# Well Logging Source Abandonments

**LICENSEE:** Precision Energy Services, Inc.

**Abandonment Location:** Land-based Well near Sweetwater, Wyoming  
Devon Energy  
Rig Name: Red Lakes 9-6-18-94

**From:** "Perry, Sean" <Sean.PERRY@weatherford.com>  
**To:** <ral@nrc.gov>  
**Date:** 08/14/2007 9:40:48 AM  
**Subject:** Precision Energy Services, Inc -- Devon Energy Well -- Red Lakes 9-6-18-94

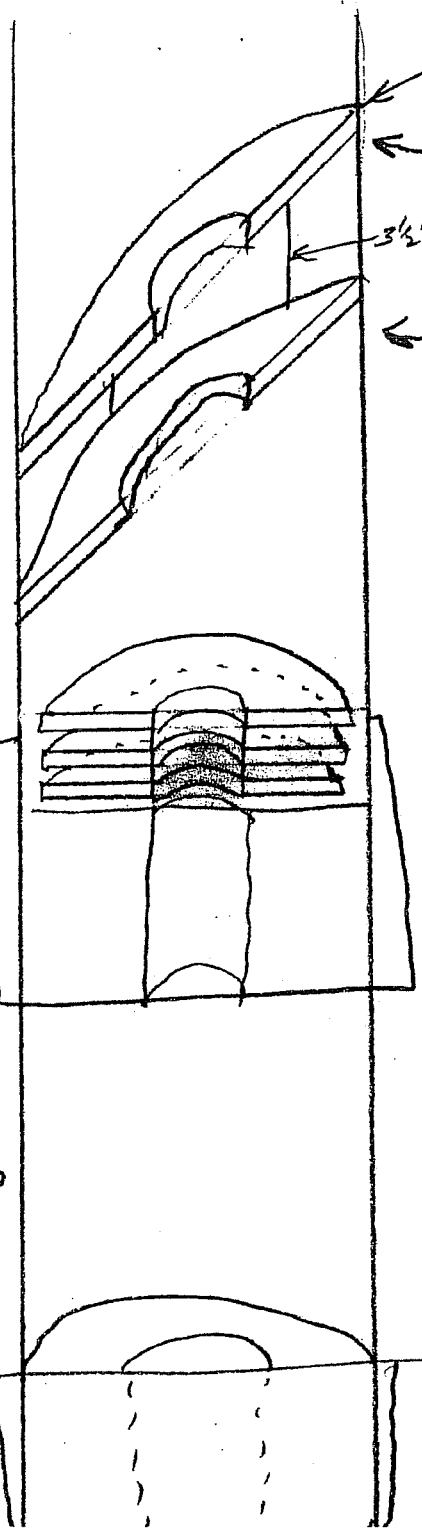
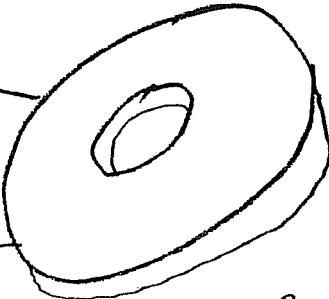
Licensee has made 11 attempts to recover the single 1.5 Ci Cs-137 sealed well logging source, but failed to recover. Licensee was able to recover the americium-241 logging source. Devon proposed abandonment plan to RIV early 8/14/07, but after review, RIV contacted licensee to express concern relative to thickness of steel rings and plates used for the deflection device. Licensee called back later that morning and indicated that Devon committed to increasing the thickness of the steel rings and plates to 1/2 inches in lieu of the 1/4 inches initially proposed. Based on this commitment, Richard Leonardi did approve the revised abandonment plan on August 14, 2007 at about 11:30 a.m. CDT.

Devon Energy Plans to cement the Cs-137 source in place using red dyed cement, up to a depth on 300 ft above the source. The deflection device they plan to use consists of two ¼" steel plates spaced apart and welded with a 3 ½" diameter pipe followed by three free floating plates that will be placed above the cement plug. I have attached a diagram of the proposed deflection device.

I somewhat understand the concept behind this particular deflection device but question the thickness of the steel plates. Call me if you have questions.

Licensee will use 300 feet of cement on top of the sealed source with the placement of the steel plates and the three floating steel rings on top of the float shoe.
